Revision: Issue 2

Cotton Dyeing & Finishing Mills Ltd

Structural Inspection Report

Observations & Actions

Incomplete bracing and inconsistent restraint detail to steel rafter

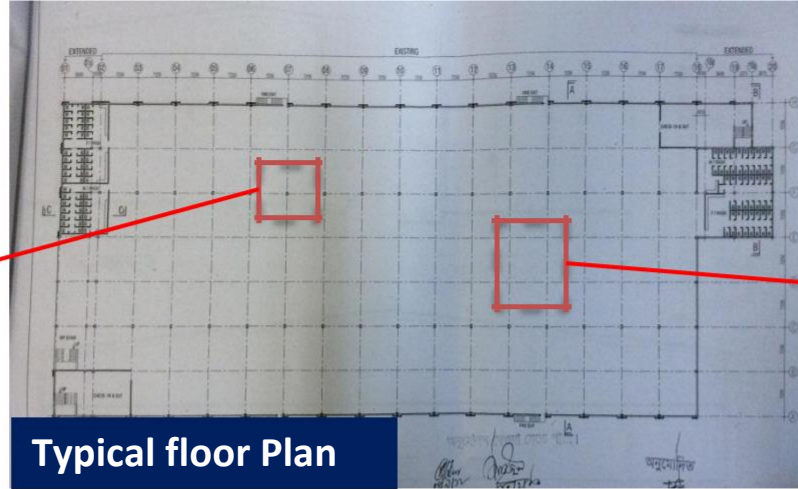
Compression flange restraints for roof rafter steel are provided at a limited number of locations.

Roof horizontal bracing for lateral stability of steel roof structure is incomplete. Building Engineer to review horizontal and vertical bracing.

Structural steel columns do not correspond with sizes shown on building section drawing.

Building Engineer to review and confirm that these are provided in accordance with the design.

Building Engineer to review adequacy of steel roof structure.

- The design of the steel roof should be checked by the Building Engineer and, if required, upgraded to support code vertical and wind loads. Specifically the provision of roof bracing (horizontal and vertical) and compression flange restraints should be reviewed.

Cracking of Building Façade

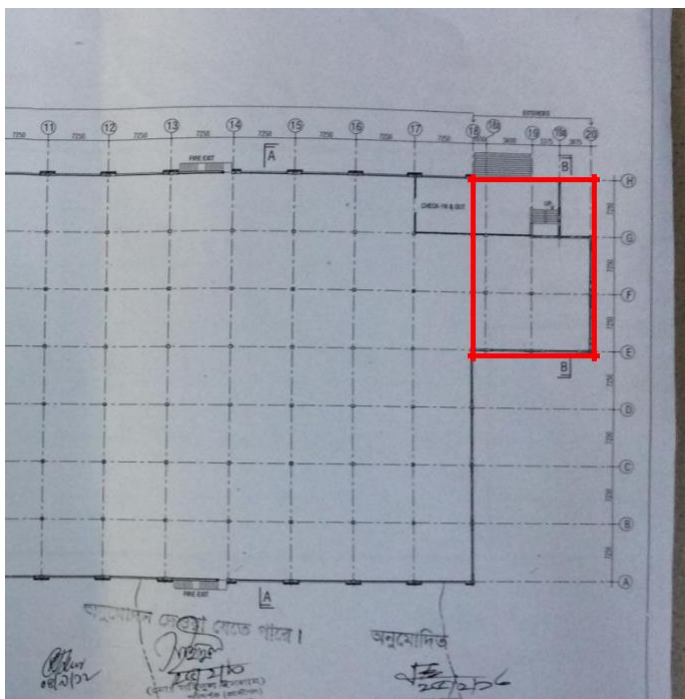
Façade cracks visible on elevations of the Garments Building.

Building Engineer to conduct routine inspection and issue maintenance schedule for façade brick walls

- Building Engineer to inspect area where cracking has occurred and propose a suitable repair to ensure that rainwater does not penetrate the building fabric.
- Building Engineer to provide a method statement for the on-going maintenance of the external facades.

Drawing Discrepancies

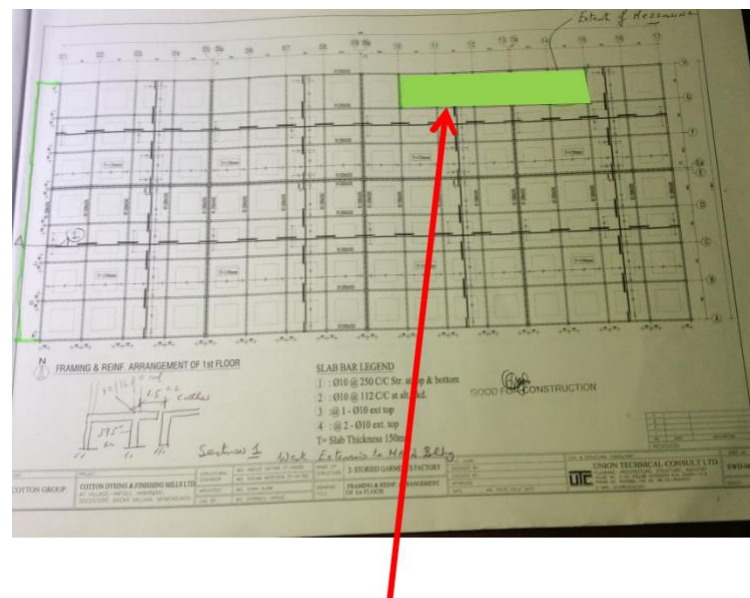
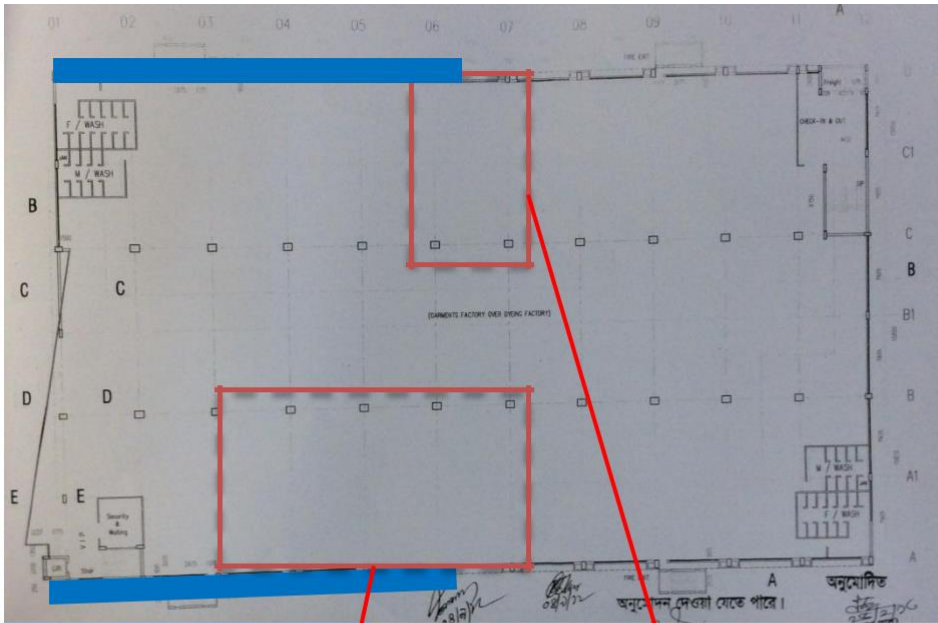
As constructed Eastern extension is rectangular on plan – this differs to layout shown on drawing

Missing drawings for the Mezzanine floor of the Garments Building

Detailed structural steel drawings for steel roof and columns not provided.

Building Engineer to check all drawings and update to match as constructed building.

- Building Engineer to survey as constructed building. Updated drawings to be prepared showing the correct as constructed layout including the steel frame structure.
- Update controlled loading plans for all floors designating allowable storage density and where storage may be placed.

**Cracking of floor finishes/slab
and management of floor loads**

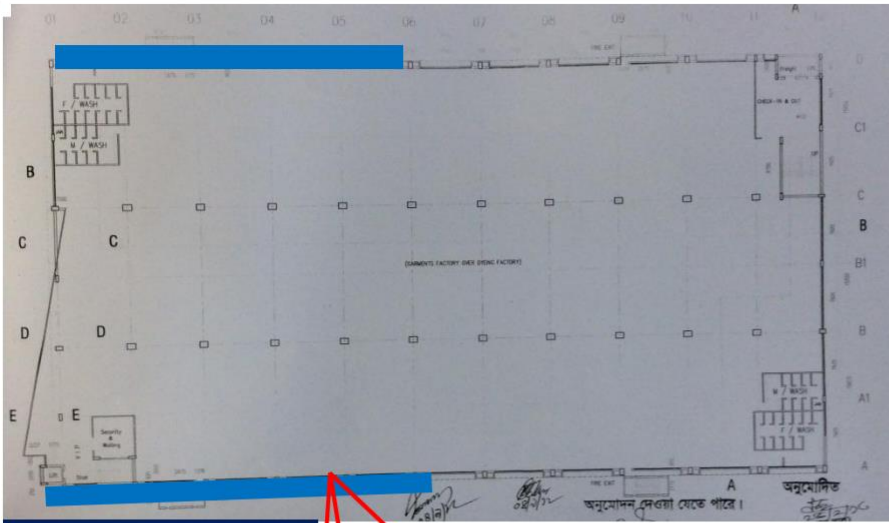
Water tanks loads

Equipment loads

Building Engineer to prepare controlled loading plans, based on floor slab and column capacity, for all floors which will designate allowable storage density and where storage may be placed. Crack repairs to be carried out as necessary.

- Produce and actively manage a loading plan for all floor plates within the factory giving consideration to floor capacity and column capacity.
- Building Engineer to review typical floor finish cracks and confirm that cracking is in finishes only. Where required, remedial works to be carried out.

Cantilever slabs

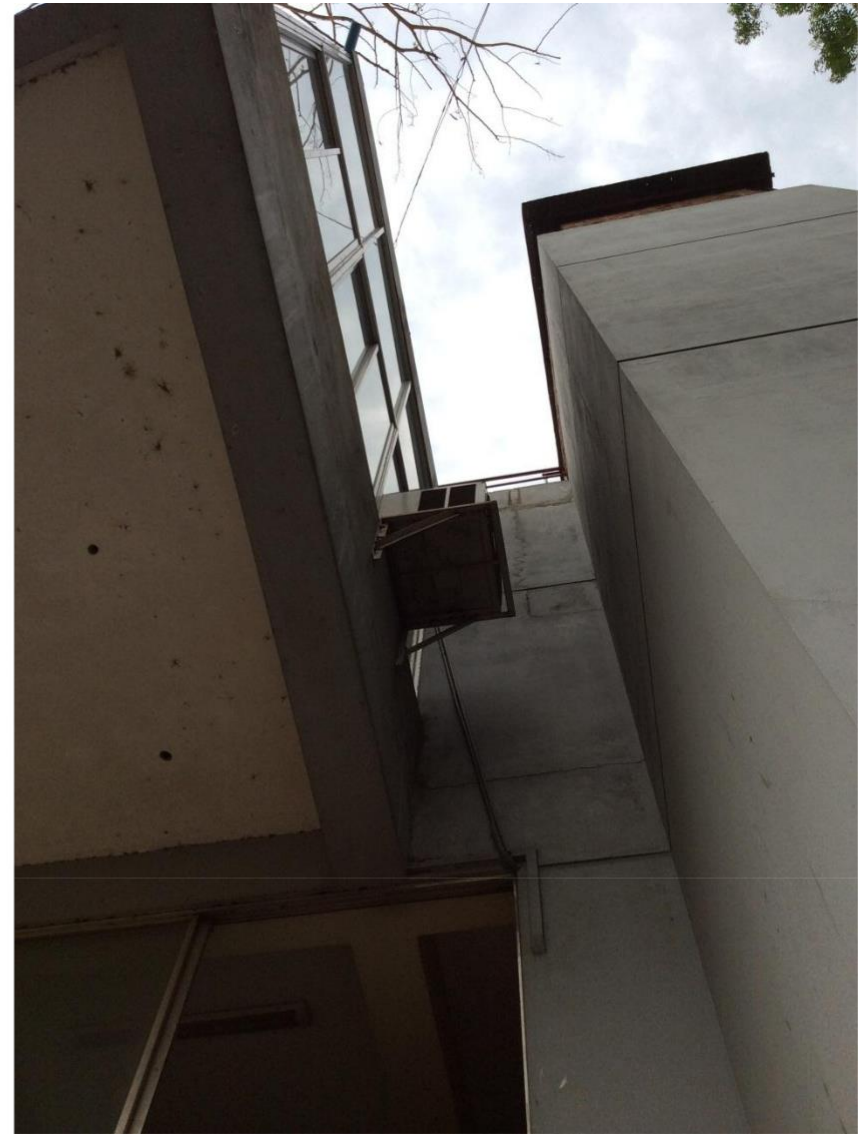
Cracks on the lower level cantilever

Cracks on the upper and lower cantilevers propagating from the column towards the tip of the cantilevers

Building Engineer to investigate reasons for cracking and implement repairs as necessary

- Building Engineer to inspect area where cracking has occurred and propose a suitable repair to ensure that rainwater does not penetrate the building fabric and cantilever slab.
- Building Engineer to provide a method statement for the on-going maintenance of the external facades.

Cracks on façade brickwork walls

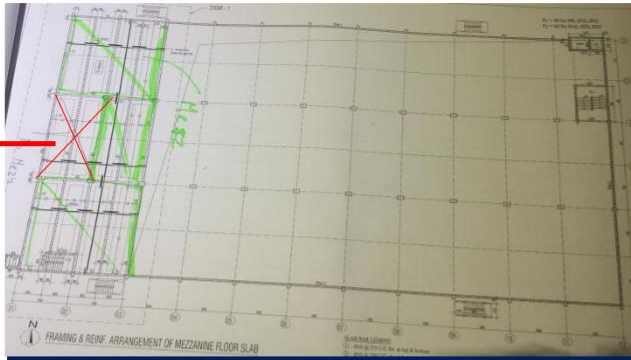
Façade cracks visible on elevations of the Knitting and Dyeing building.

Building Engineer to conduct routine inspection and issue maintenance schedule for façade brick walls

Mezzanine RC drawing

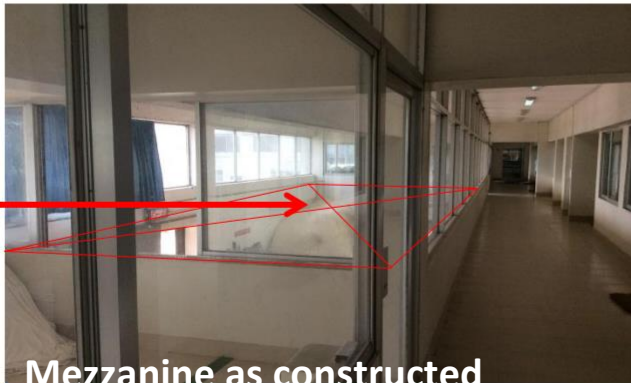
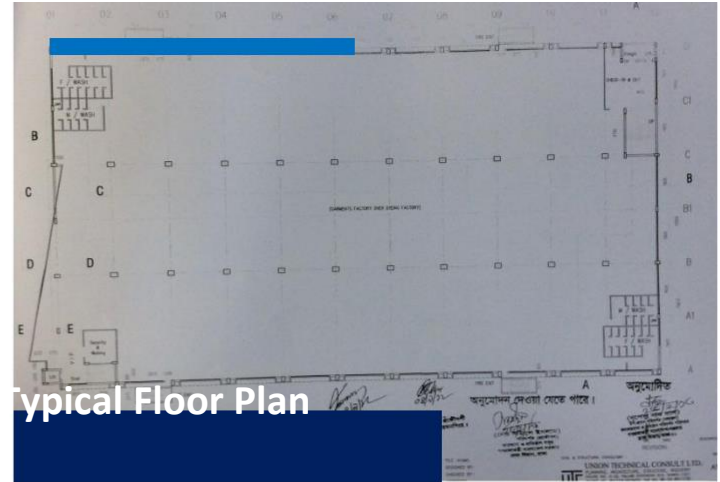
Mezzanine is shown covering 2 full bays at the west end of the building on the RC drawing. As constructed it only covers 1 bay at the middle section of the mezzanine.

- Building Engineer to survey as constructed building. Updated drawings to be prepared showing the correct as constructed layout.
- Update controlled loading plans for all floors designating allowable storage density and where storage may be placed.
